**Appendix I:**

**Comments Received on the DEIS**

## **LIST OF GROUPS AND INDIVIDUALS WHO COMMENTED ON THE DEIS**

Figure 8 - GCT Track Diagram

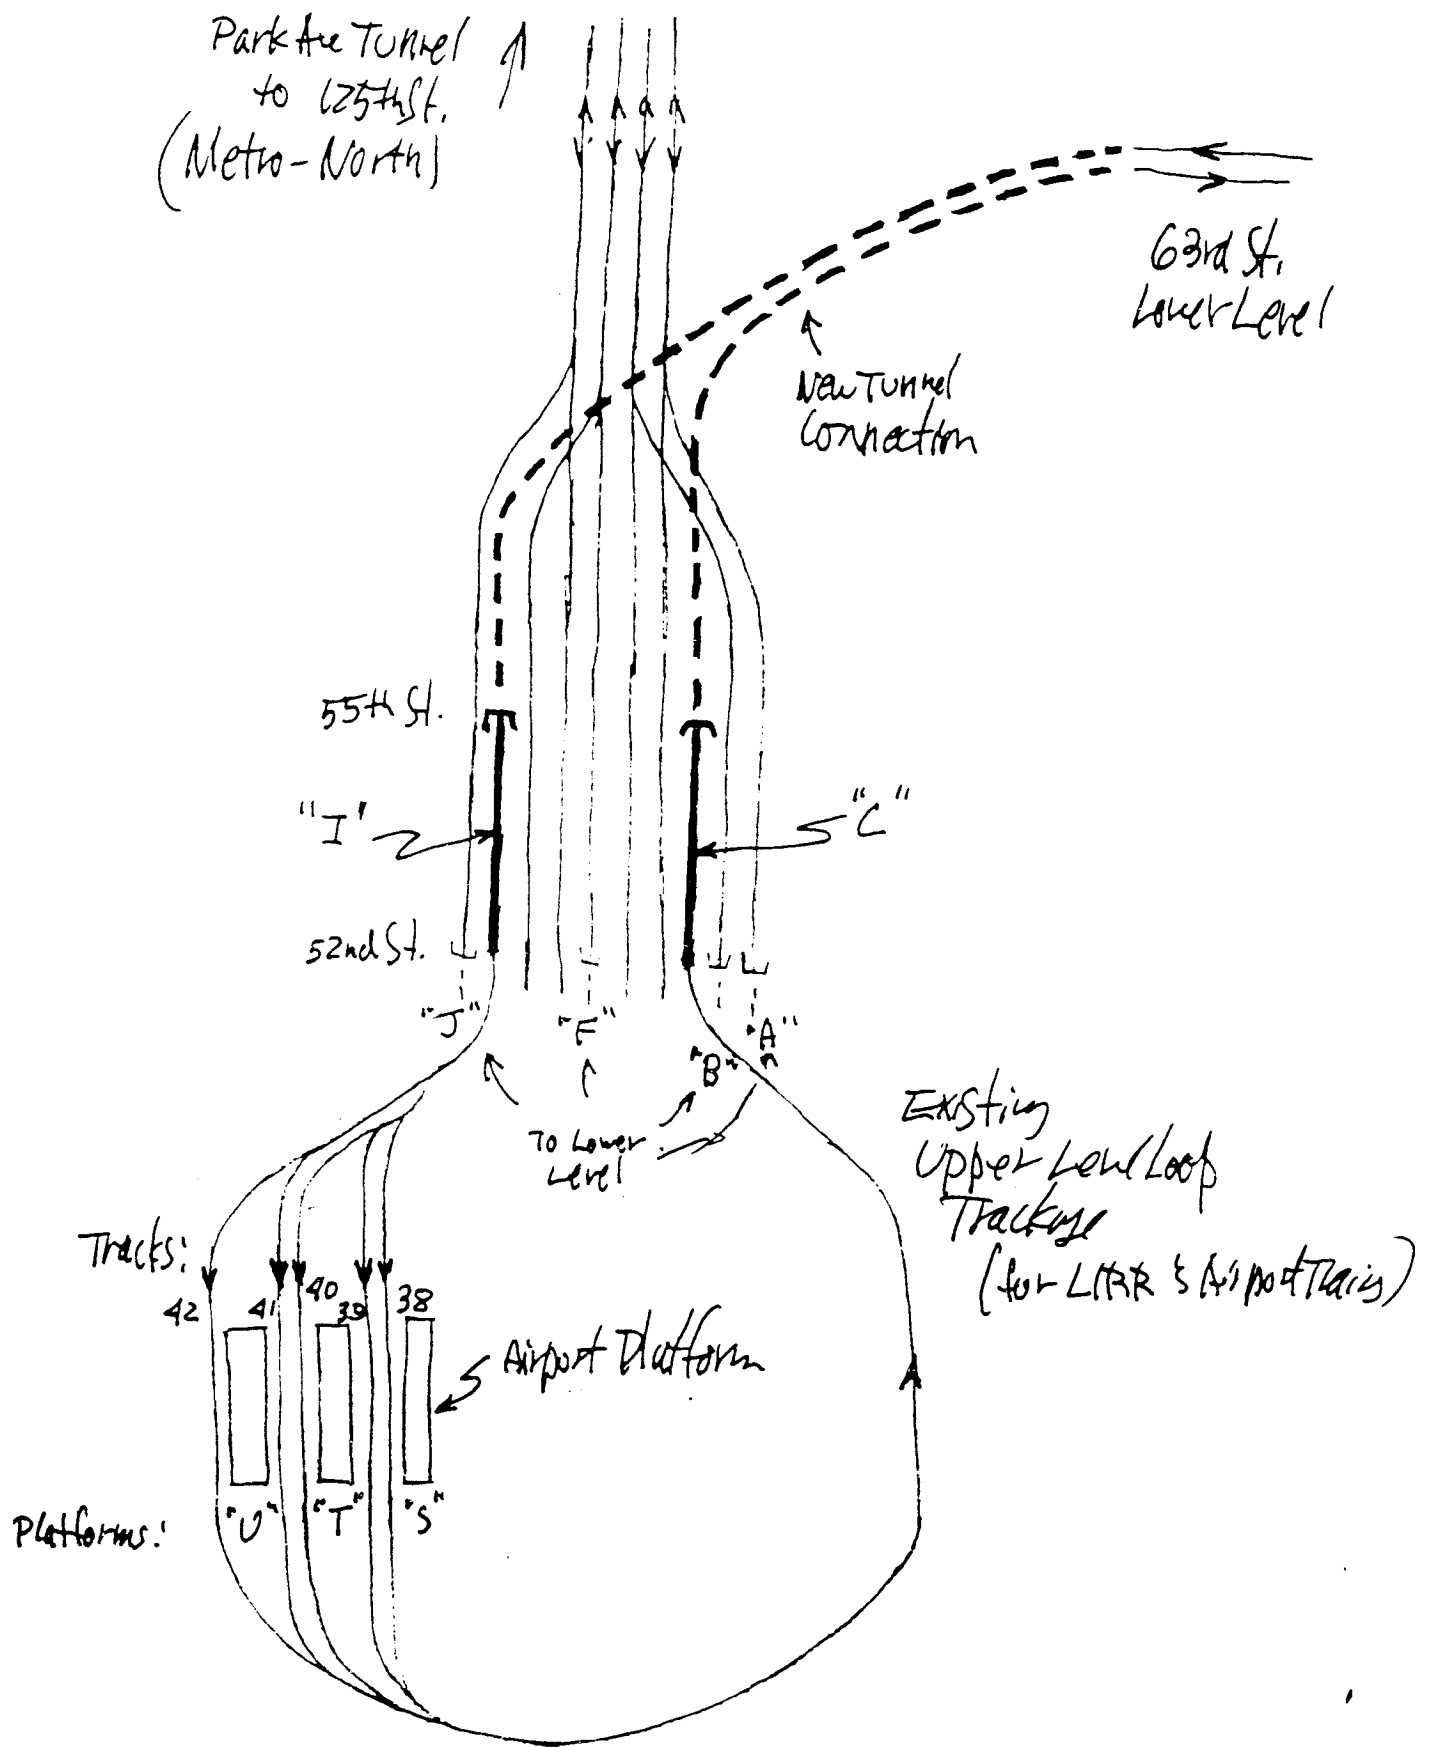
The key feature of the APPLE CORRIDOR is the completion of LIRR access to Grand Central Terminal. To keep costs down, and to maximize traveler convenience, the plan would use the existing upper level loop of Grand Central with its five platform tracks, as shown schematically in Figure 8. Typical operation would be for LIRR trains to use the four westernmost tracks (nos. 39-42) and their two island platforms (designated T and U). Airport trains would use the fifth track (38) and with its own separate platform (S). This would keep airport travelers out of the way of commuters.

Figure 9 - Comparison of GCT and WTC Terminal Loops

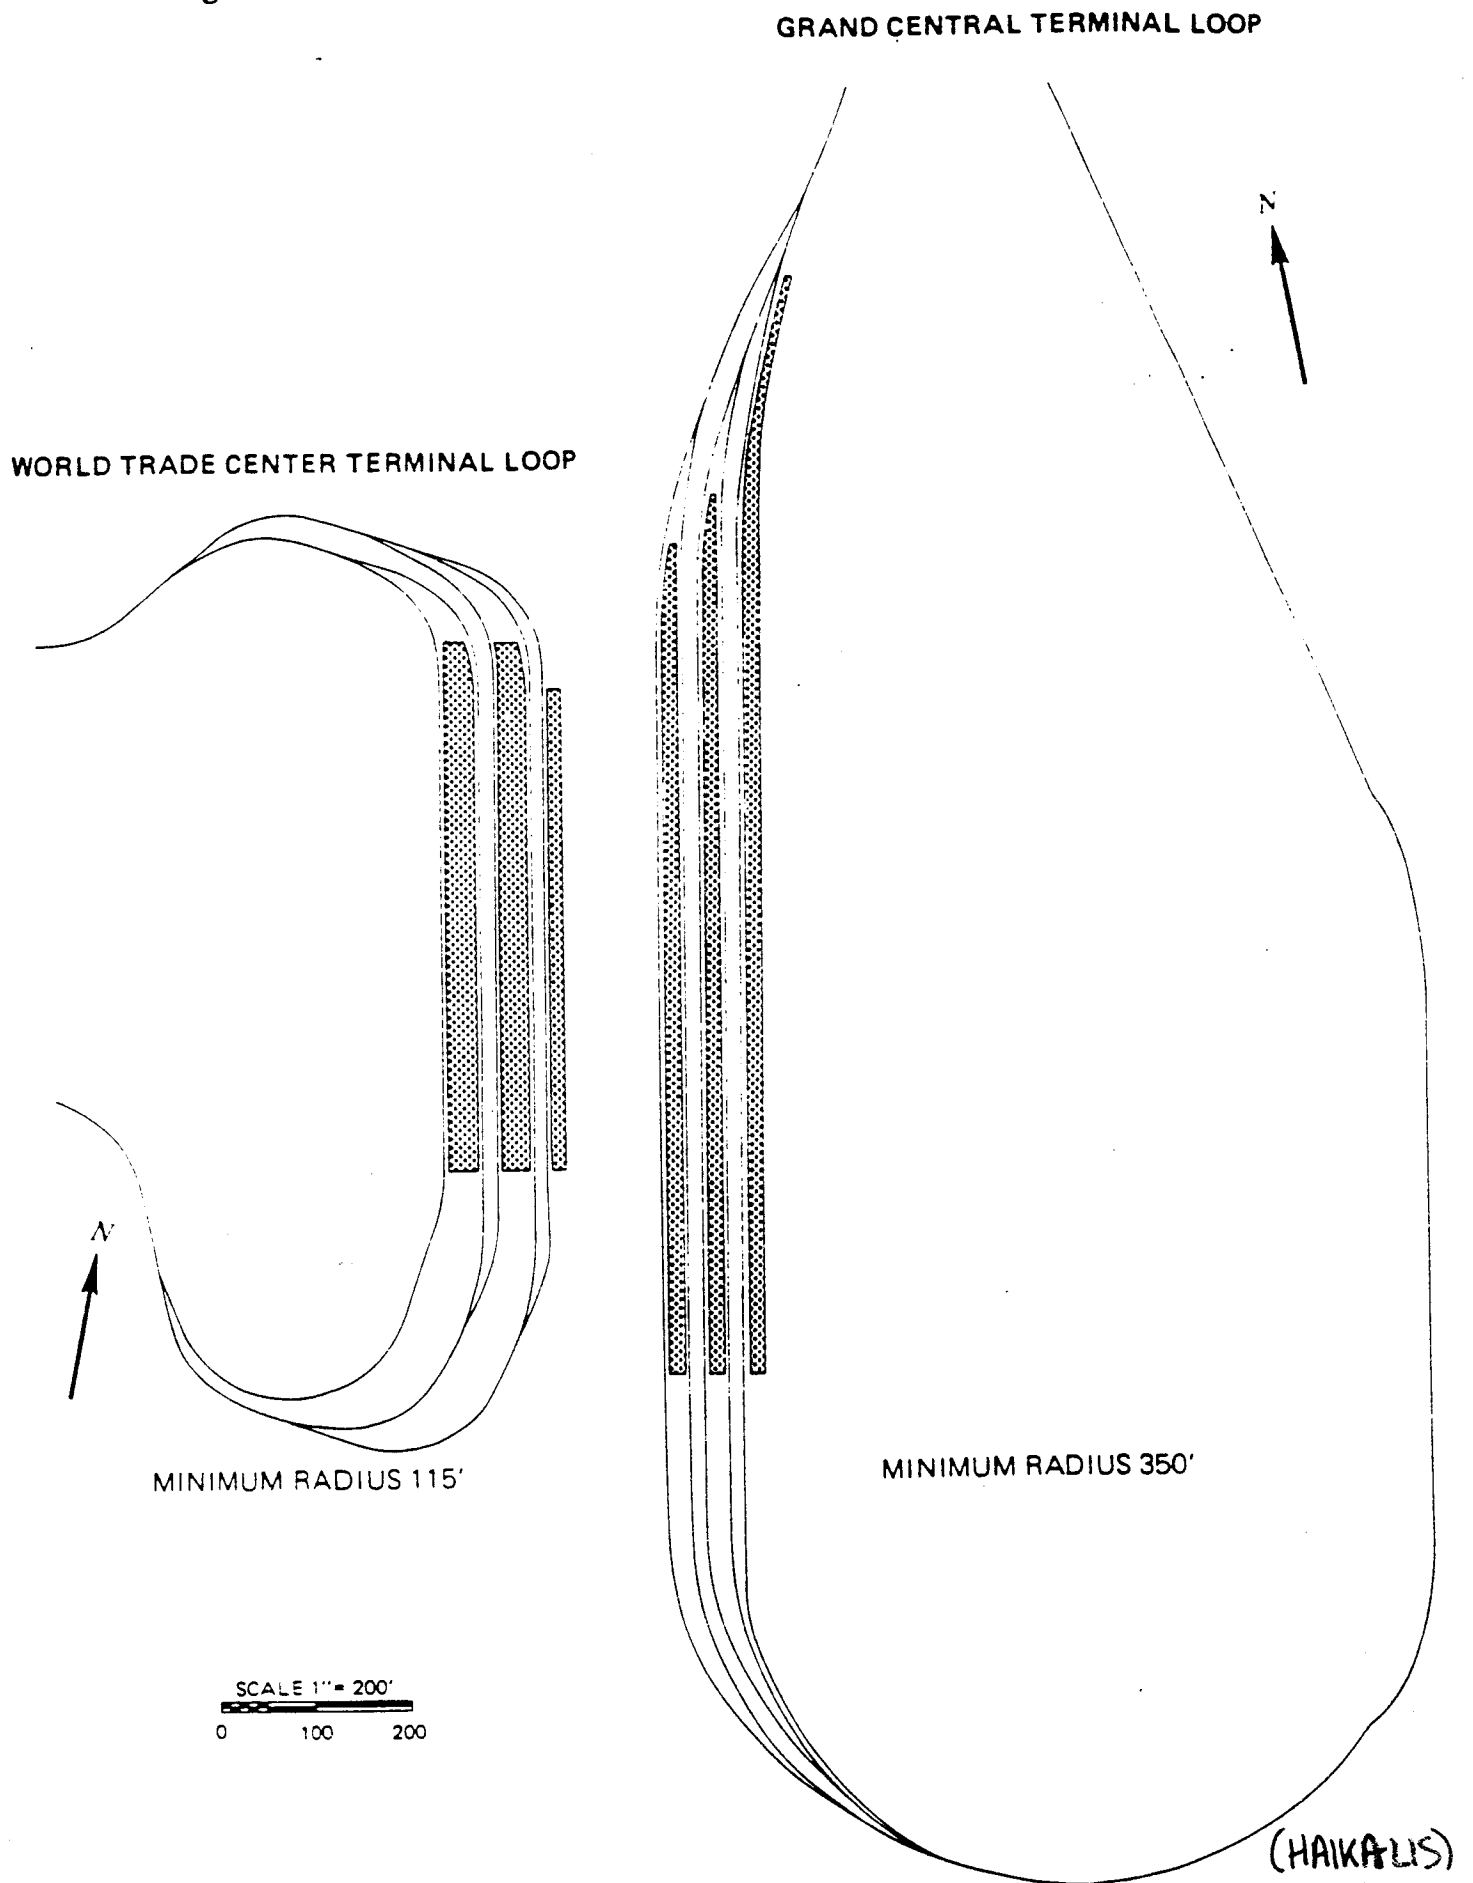
CBT's plan would provide a high capacity loop system that is operationally similar to PATH's World Trade Center terminal. The layouts are shown at the same scale in Figure 9. PATH operates trains at a rate of 40 trains per hour during the busiest peak periods. Curves are much tighter at the Trade Center. The Grand Central loop track has a generous 350 foot radius in comparison to PATH's 115 foot radius. There is no reason why LIRR trains could not operate at 15mph or faster around the loop. The new local-express connection to the Queens Blvd. Subway line now under construction in Long Island City has the same radius curve on its "mainline". A goal of 30 scheduled trains per hour for the loop is not unreasonable.

Figure 10 - LIC/Sunnyside Track Diagram

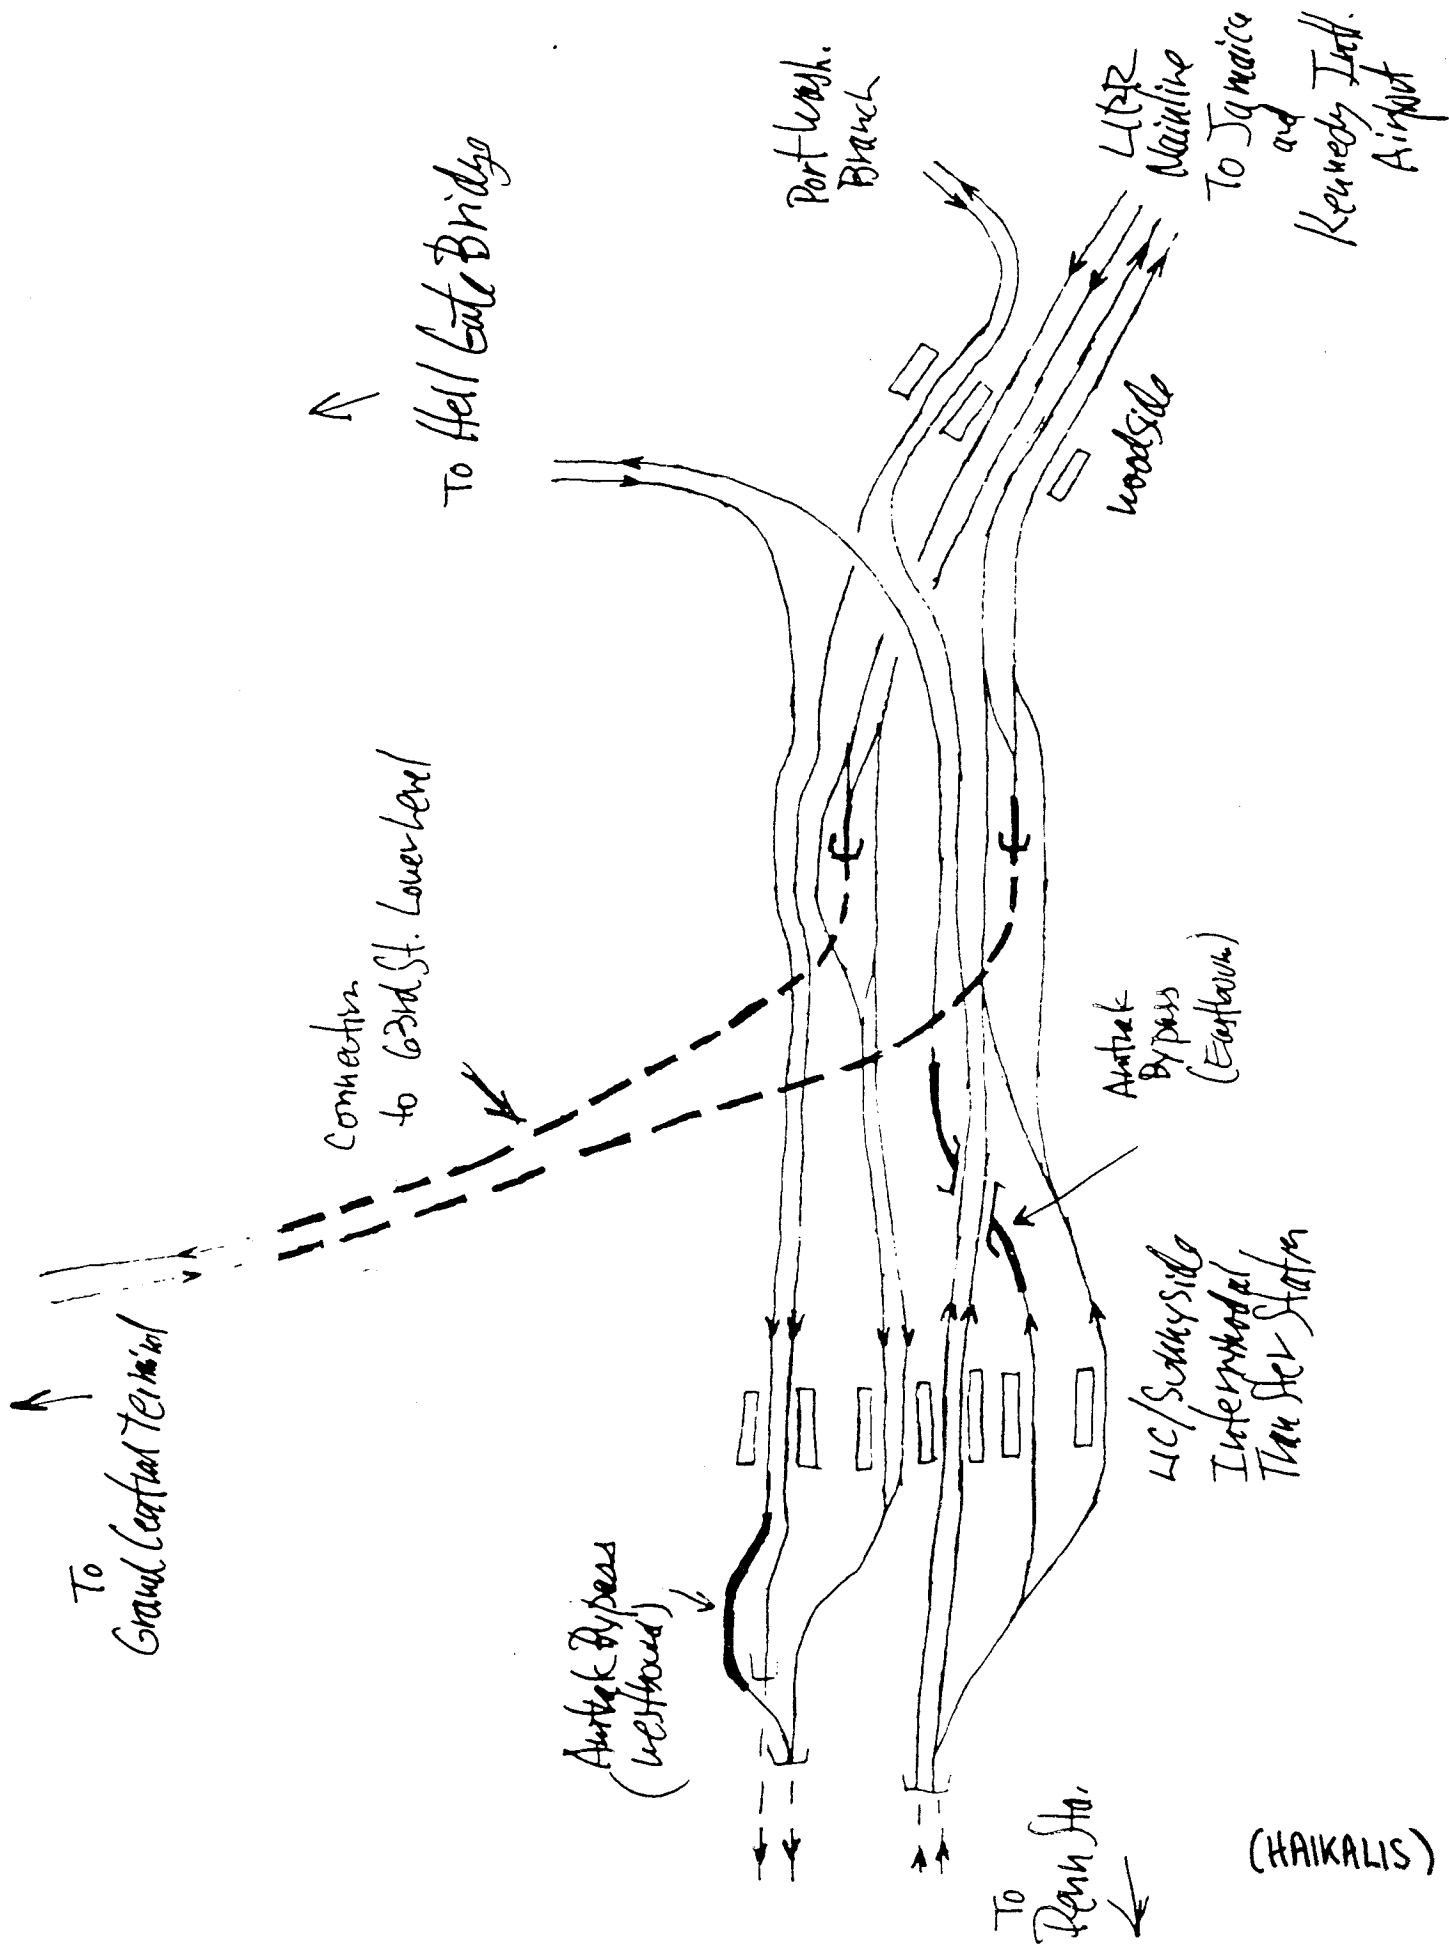
In Long Island City the APPLE CORRIDOR would require construction of two tracks from the end of the existing lower level of the 63rd St. tunnel at Long Island City to existing LIRR trackage at Harold Tower, as shown schematically in Figure 10. Two 3,000 foot long cut and cover tunnels would be
